BREAKERS
HOTEL
RENOVATION

Breakers Hotel Elevator Tower Height Increase Request

Breakers Hotel Window System Approval
November 7, 2019

NORTH ELEVATION
 A3.01

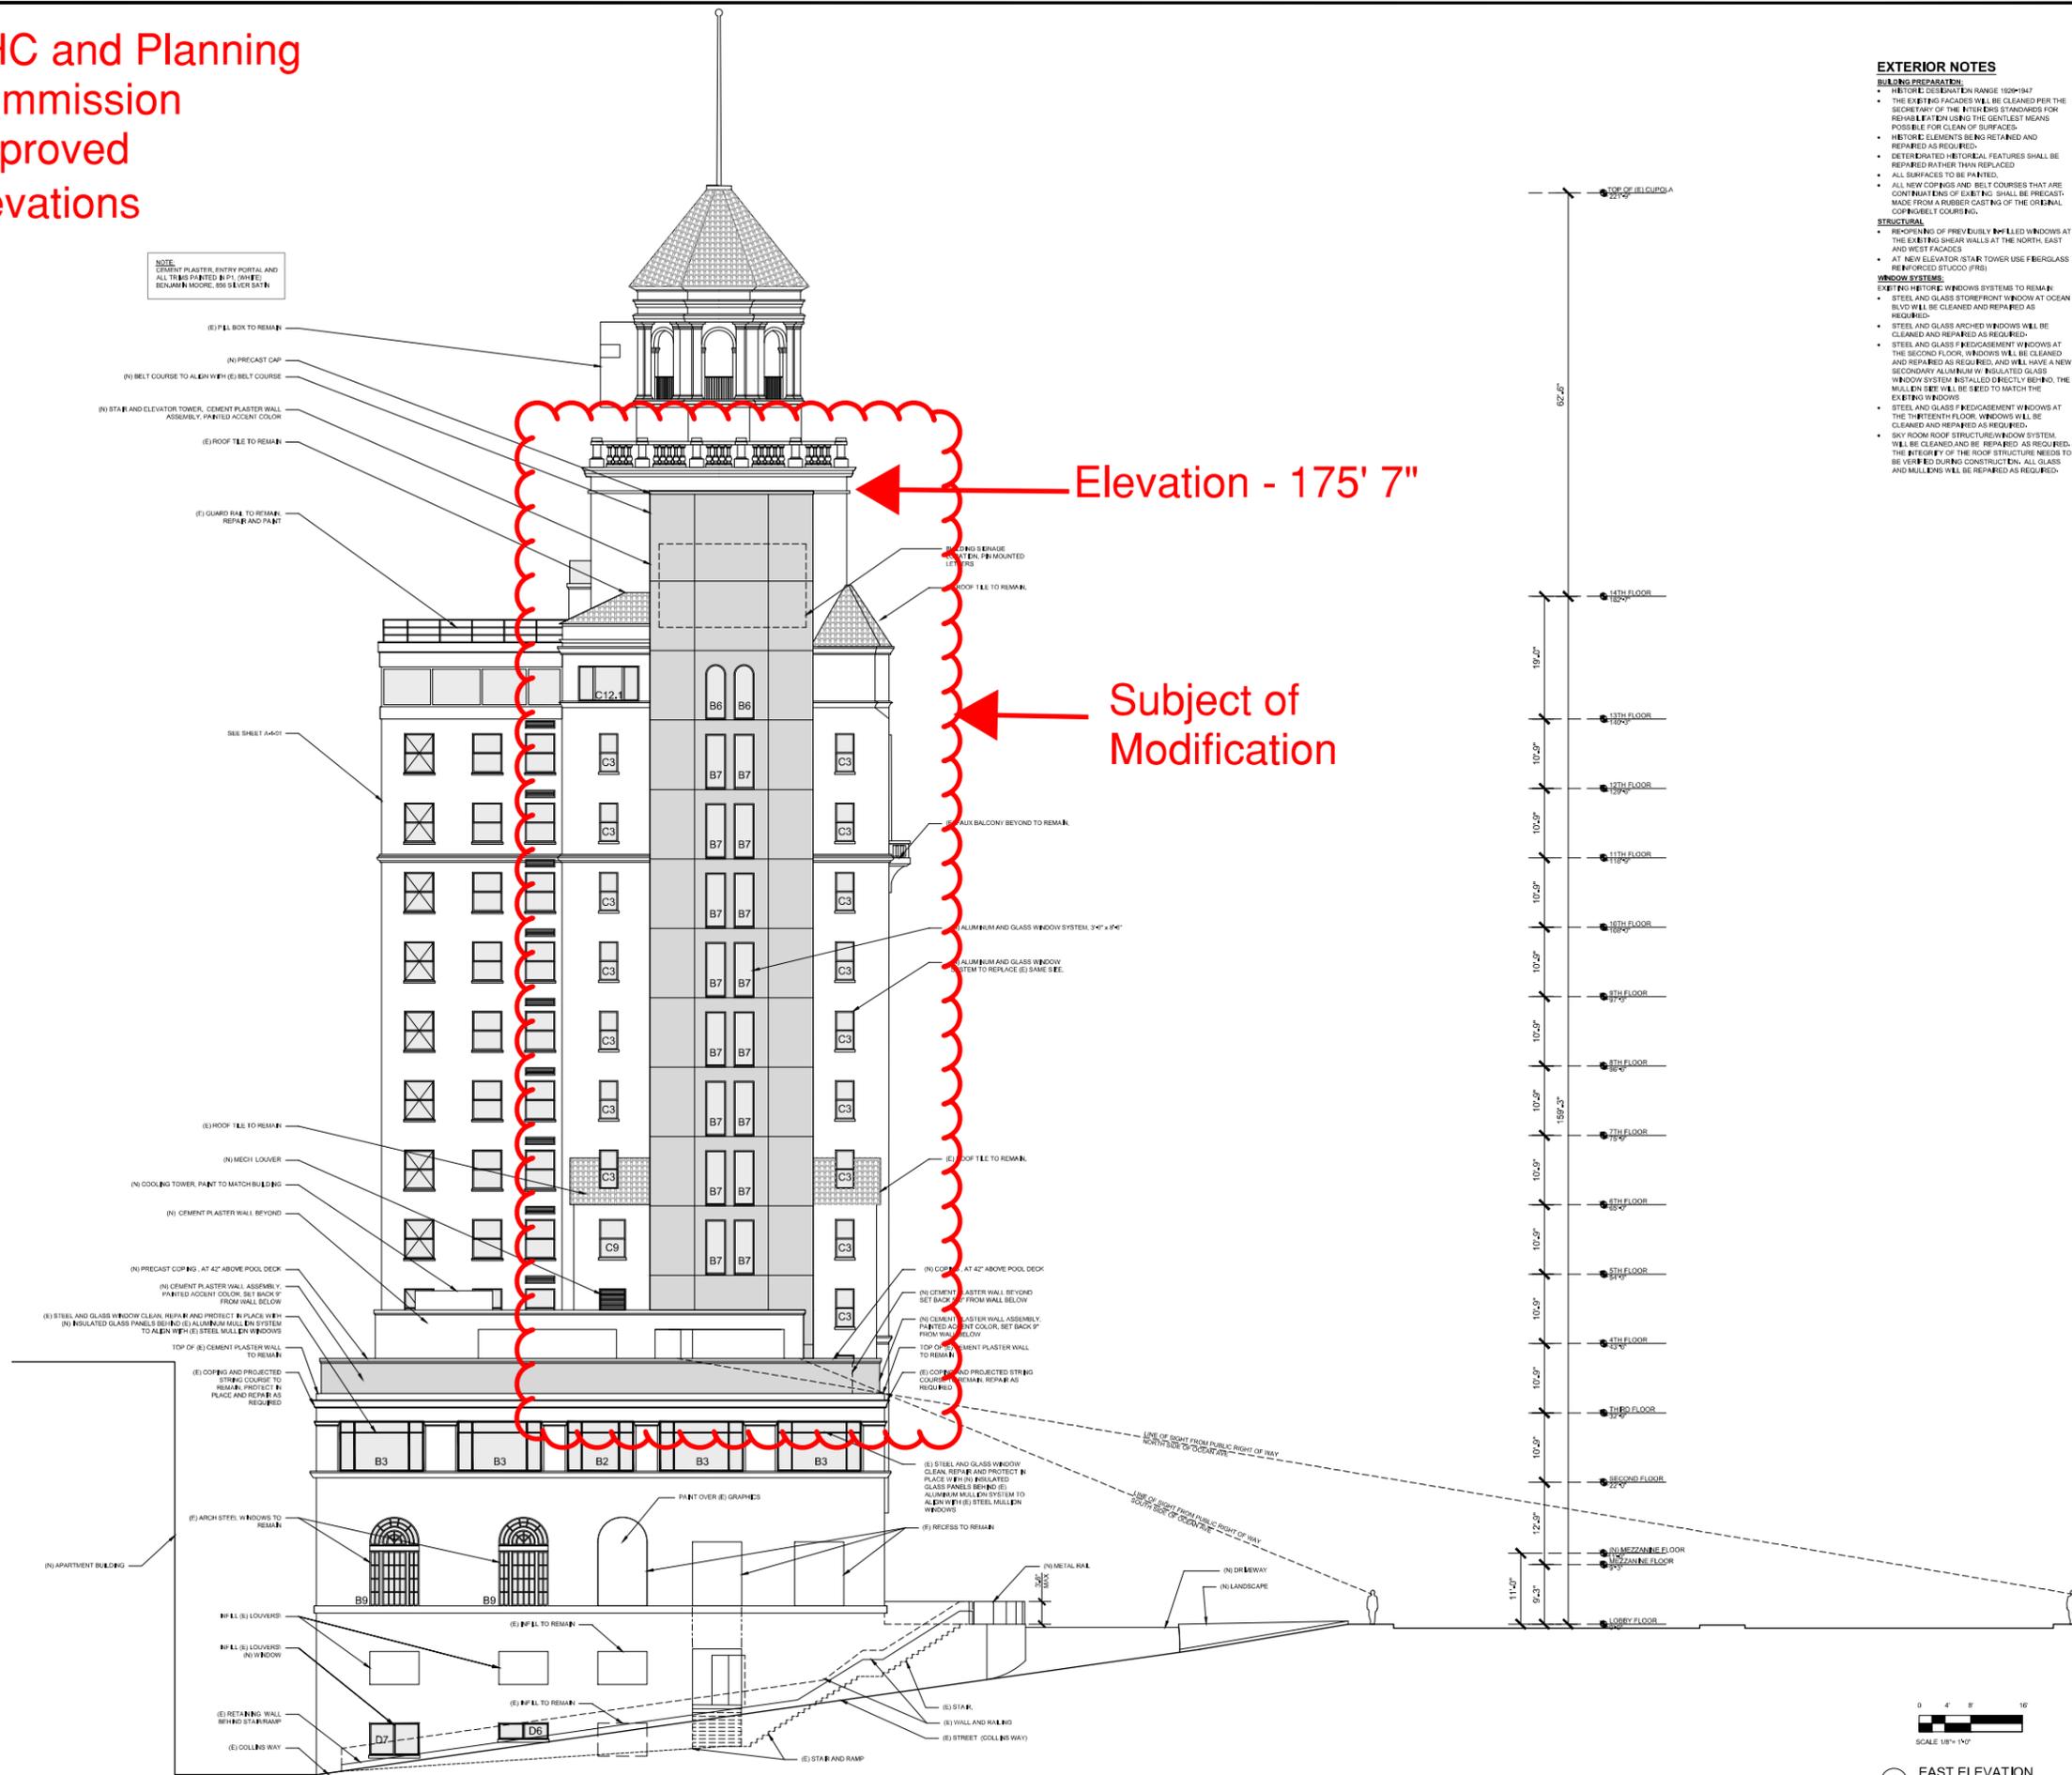
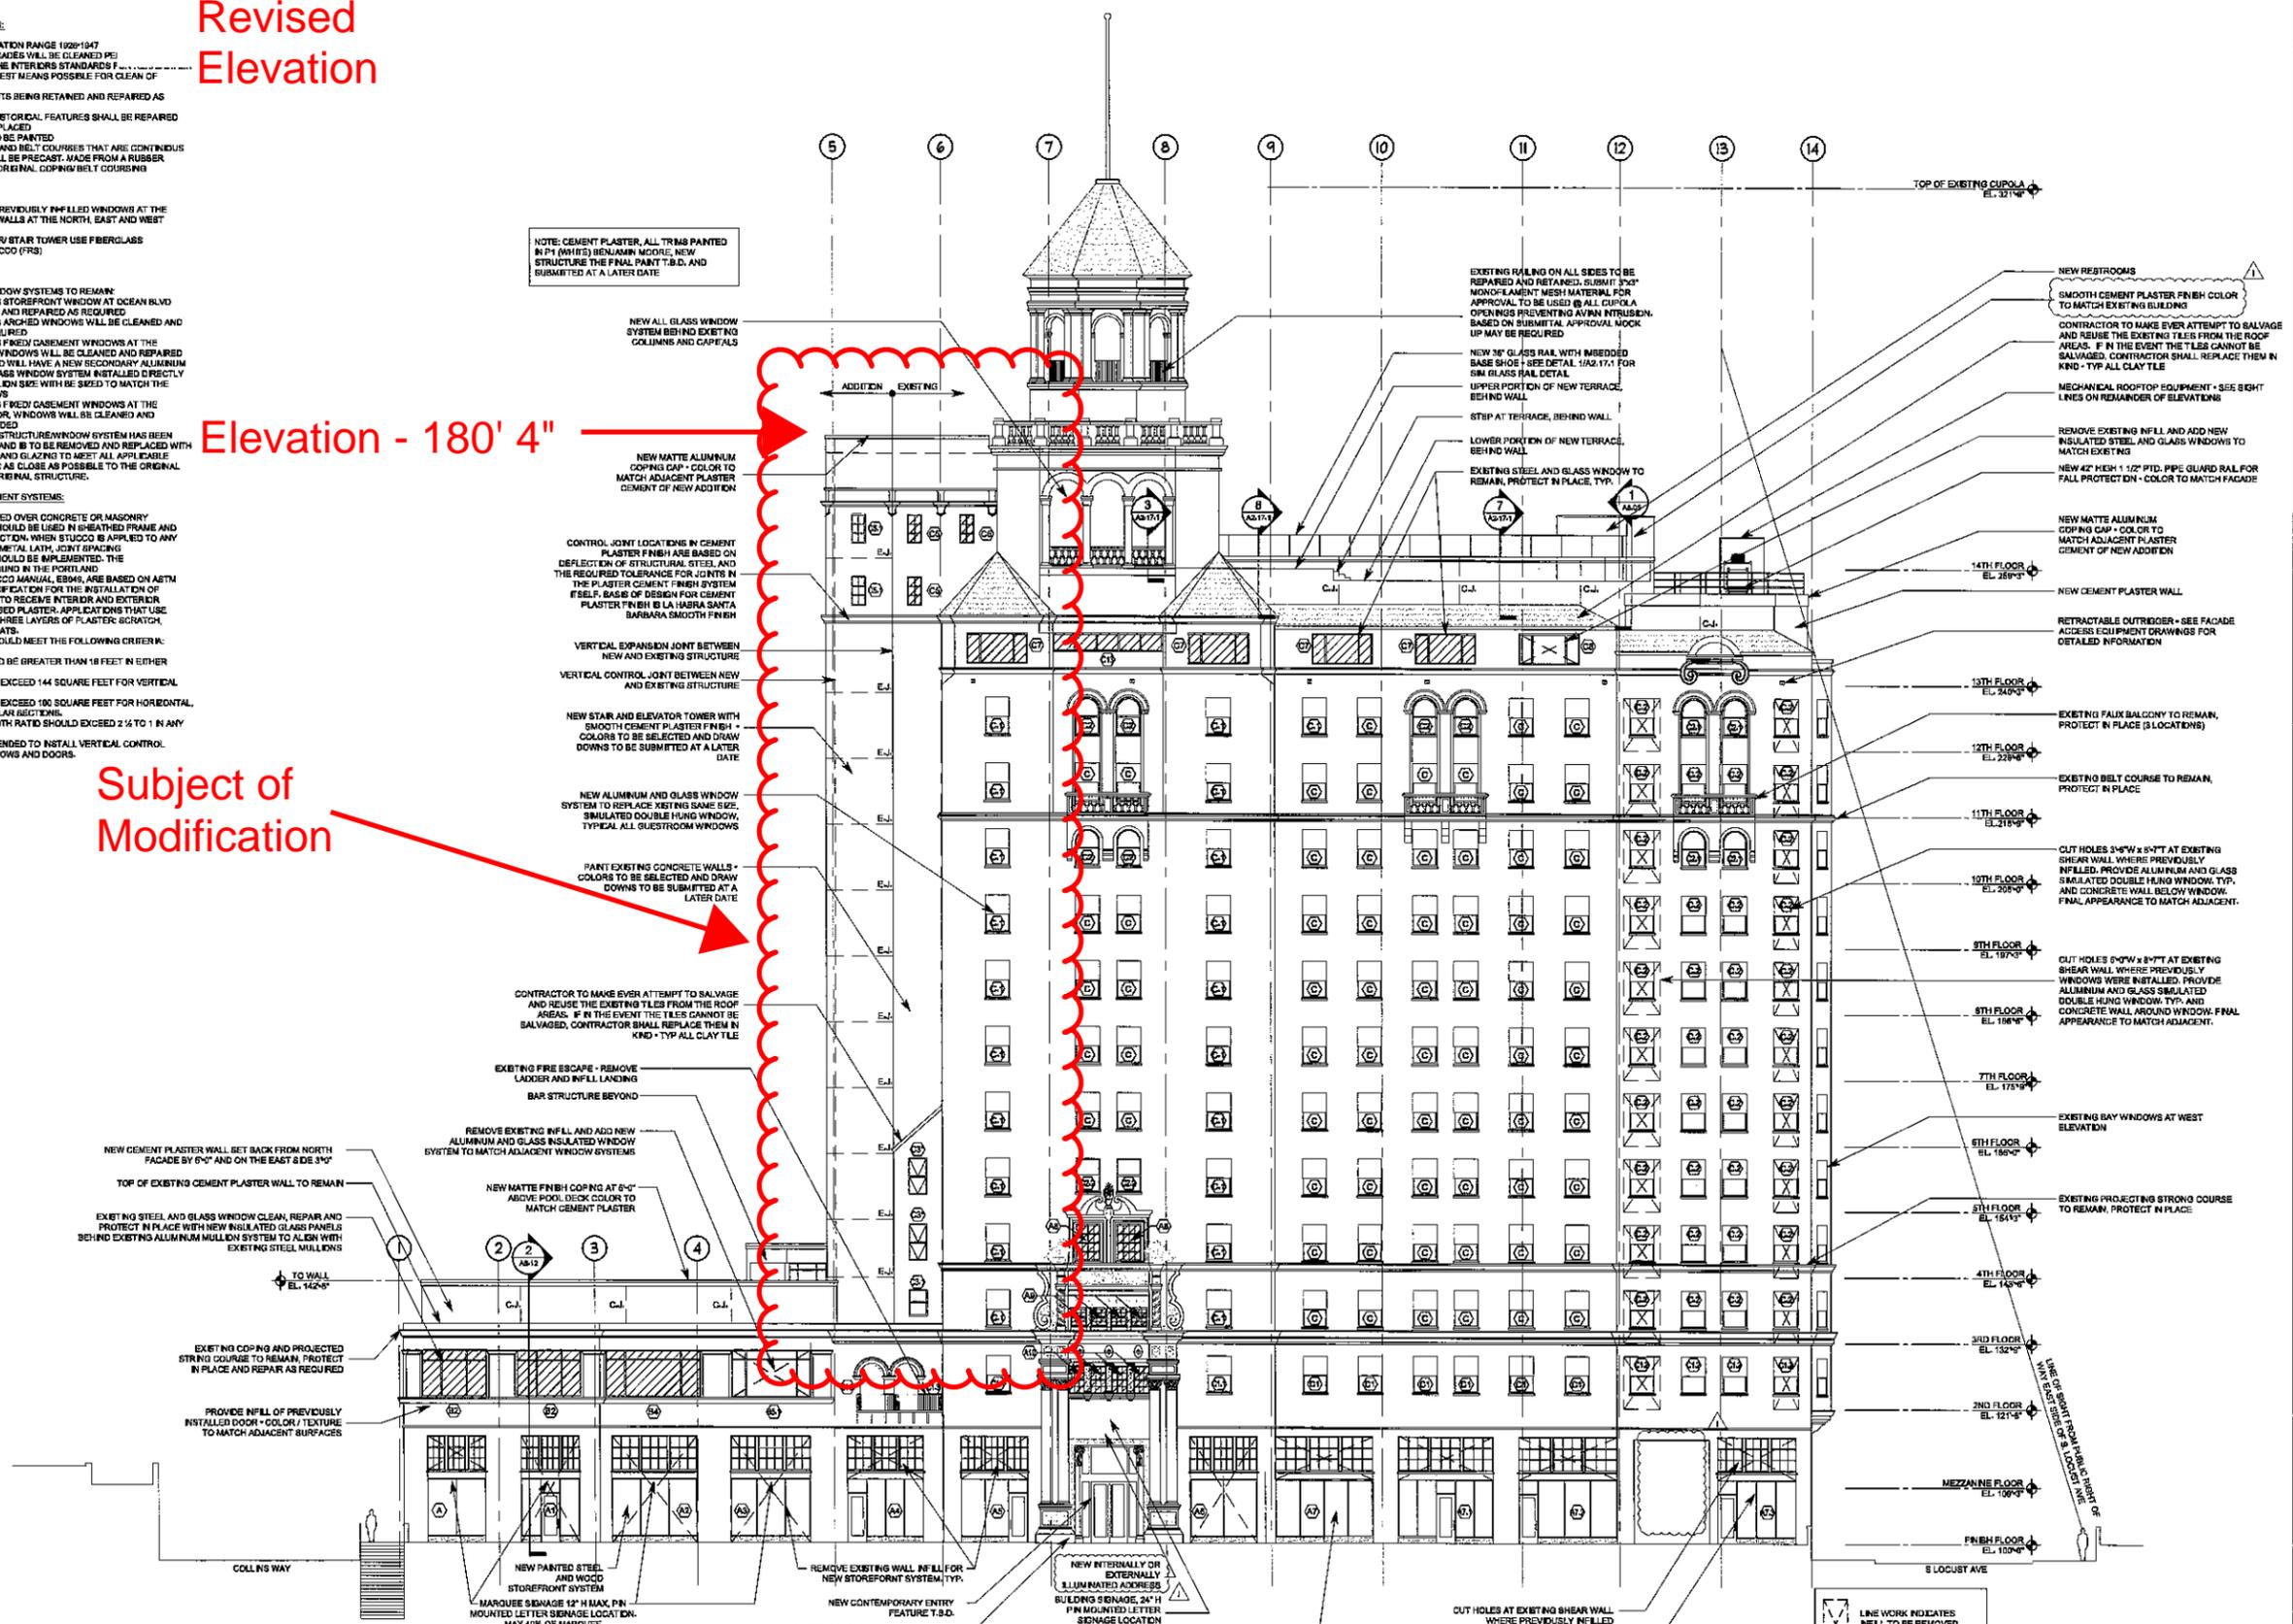
Subject of Modification

Subject of Modification

View of East façade with existing profile of the elevator / stair tower

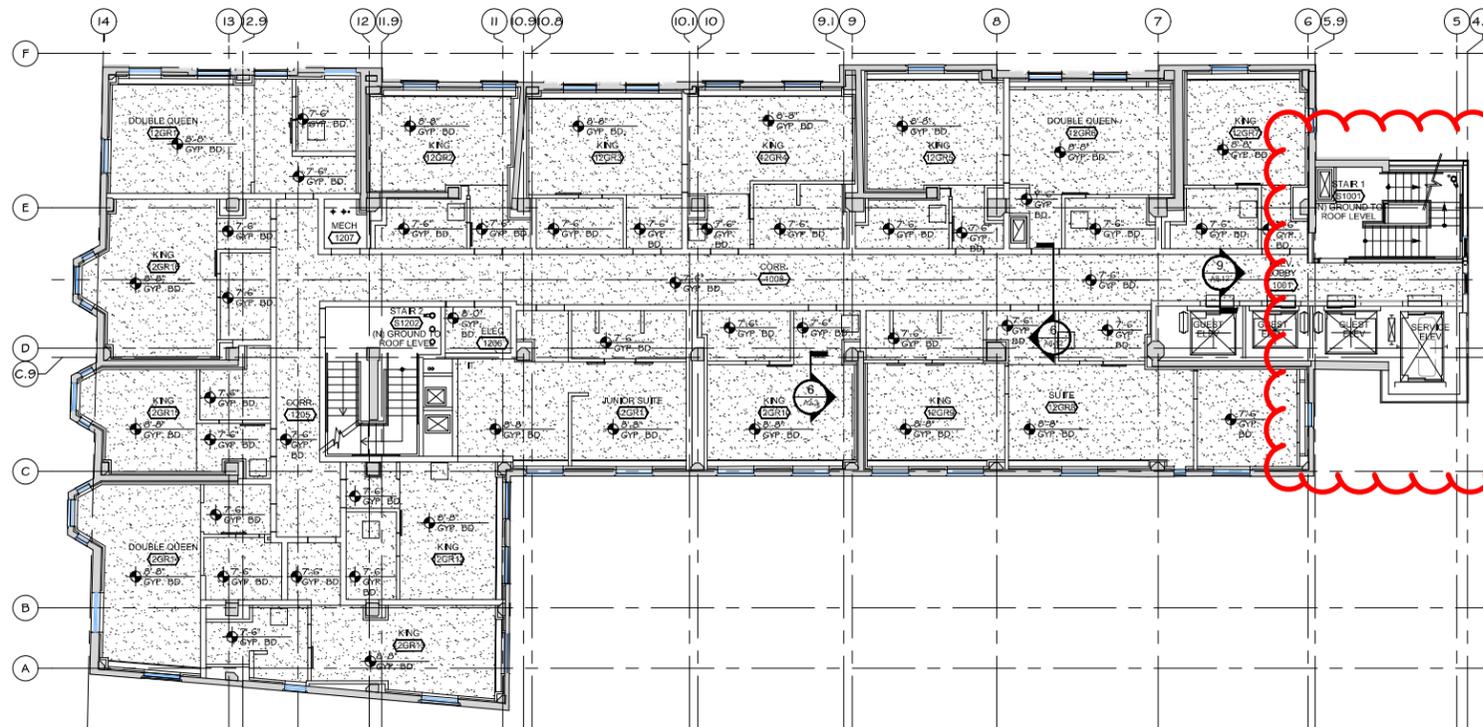
After a lengthy process of measuring, remeasuring, scanning, etc. it was determined that the existing structural elements in the basement would allow for only one type of code compliant, gurney elevator system. A code compliant, gurney sized, Kone overhead traction elevator with basement mounted machinery has been custom designed to fit within the existing structure. The result is a tower height increase of 4' 9" from the approved plans. The height increase is a result of the necessary overrun of the elevator system.

During the Part 2 application process, working with the State Historical Preservation Office, it was strongly suggested that the design team incorporate existing building features such as cornices, windows, moldings into the new tower design. This design change has been incorporated into the current propose design.

- 1.) approve the necessary tower height increase that would allow us to install these critical life safety systems,
- 2.) approve the incorporation of façade detailing (cornices, windows, moldings) on the new tower element as shown on the new design.
